UNITED STATES PATENT AND TRADEMARK OFFICE

APPLICATION NO.	FILING DATE	FIRST NAMED INVENTOR	ATTORNEY DOCKET NO.	CONFIRMATION NO.
10/519,862	12/29/2004	Gerhard Fuhrer	ZAHFRI P707US	9283

Office Action Summary	Application No.	Applicant(s)	
	10/519,862	FUHRER, GERHARD	
	Examiner	Art Unit	
	David D. Le	3681

DETAILED ACTION

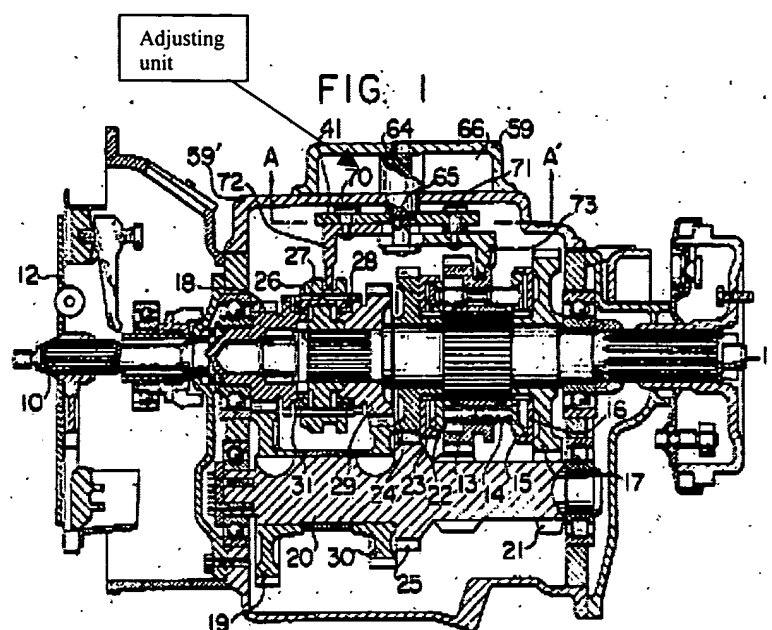
Hirozawa (Figs. 1-3; column 1, line 48 – column 4, line 38) discloses a speed change mechanism comprising:

- A plurality of sliding sleeves (i.e., Fig. 1, elements 13 and 26) the sliding sleeves being torsionally fixed with a main shaft (i.e., Fig. 1, element 11) and forming locking with idler wheel (i.e., Fig. 1, elements 17, 24 and 29) to be shifted by means of axial displacement;
- At least one adjusting unit (i.e., Fig. 1, element Adjusting unit above) in communication with each of the plurality of sliding sleeves to actuate each of the plurality of sliding sleeves;
- An actuator (i.e., Fig. 1, being the combination of elements 64, 65, 41, 70, 71, 72 and 73) selected by the at least one adjusting unit such that a shifting actuation of the respective sliding sleeve is possible;
- Wherein the fork (i.e., Fig. 1, element 72 or 73) reaches dead centers of a shifting path of the sliding sleeve during a circular motion of the shaft (i.e., Fig. 1, element

64) and that the sliding sleeve maintains the form-locking connection of the idler wheel to be shifted in the dead center (i.e., Fig. 1);

- A governor (i.e., Fig. 3, element 51) for coordinating the shifting operation of the vehicle.

Hirozawa lacks:

- Wherein the adjusting unit includes an electric servo-motor and a pin which actuates the sliding sleeve, the pin is provided eccentrically on a motor shaft of the servo-motor as the adjusting unit;
- Wherein at least one detection device is provided for detecting rotational positions of the motor shaft; and
- Wherein the detection device is integrated into the adjusting unit.

Fig.1

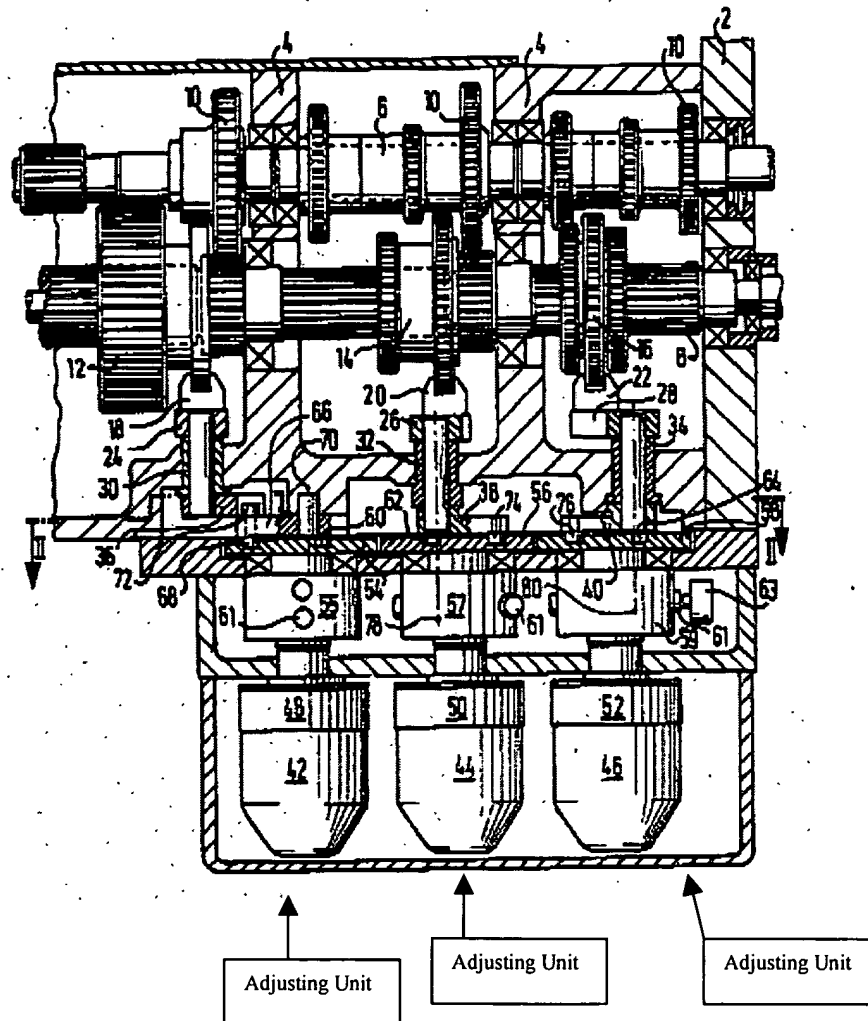
Adam (Figs. 1-8; column 1, line 29 – column 6, line 53), on the other hand, teaches a shifting device comprising:

- A plurality of adjusting units (i.e., Fig. 1, elements Adjusting units above);
- Wherein each of the adjusting units includes an electric servo-motor (i.e., Fig. 1, element 42, 44 or 46) and a pin (i.e., Fig. 1, element 68, 74 or 76) for operatively actuating the sliding sleeve;
- At least one detection device (i.e., Fig. 8, being one of elements 171-178) is provided for detecting rotational positions of the motor shaft; and
- Wherein the detection device is integrated into the adjusting unit.

It would have been obvious to one of ordinary skill in the art at the time the invention was made to modify Hirozawa such that the hydraulic servo-shifting assembly is replaced with the electric servo-motor assembly, in view of Adam, in order to provide a shifting assembly that is simple in construction and inexpensive to produce (Adam, column 1, lines 24-27).
